PRODUCT ADVISORY

Data Sheet Specification Change for Intersil Product ISL5960*

**Refer to:
PA10121**

Subject: **Data Sheet Specification Change for Intersil Product ISL5960***

PA10121 – Typical Application

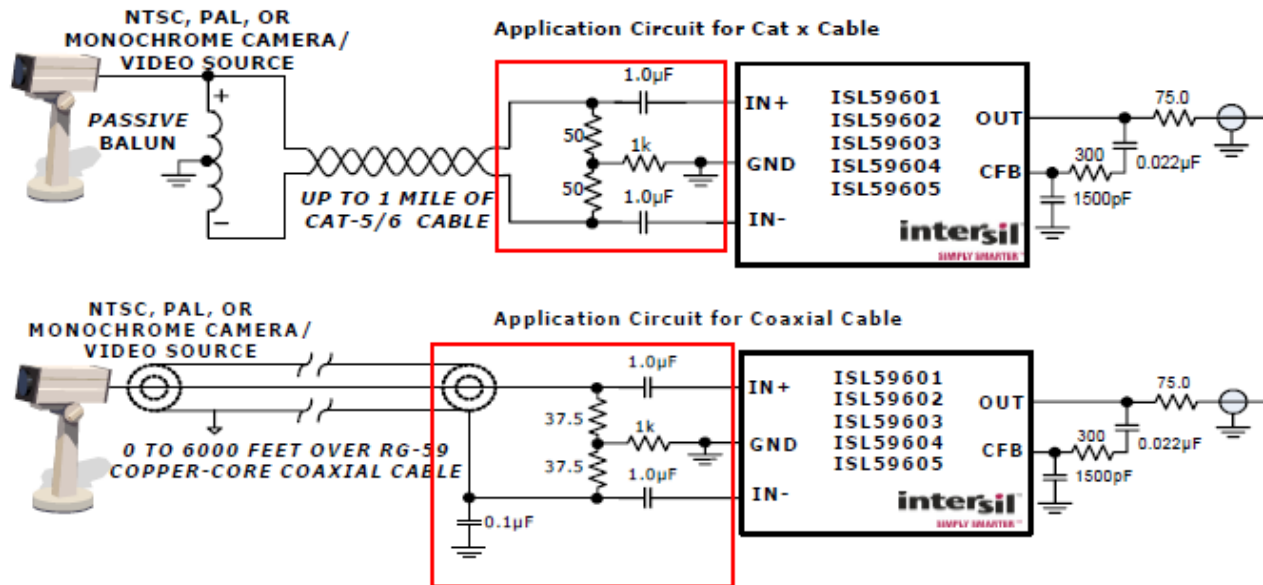
- i) The *Register Listing* has been updated to correct the bit assignments for Register 4. The bits were swapped for each function in the previous revision of the data sheet. Examples of the correct and incorrect bit assignments for Register 4 are included for reference.
- ii) The configuration of the recommended termination network for the Cat X and coaxial cables has been updated throughout the data sheet. Examples of the new and old termination network for the Typical Application are included for reference. While any designs based on the old network will continue to work, the new network provides significantly better performance for coaxial cables. The new termination can also be implemented on a board designed for the old termination simply by changing values of and/or not installing the appropriate resistors and capacitors.

New – Termination Network
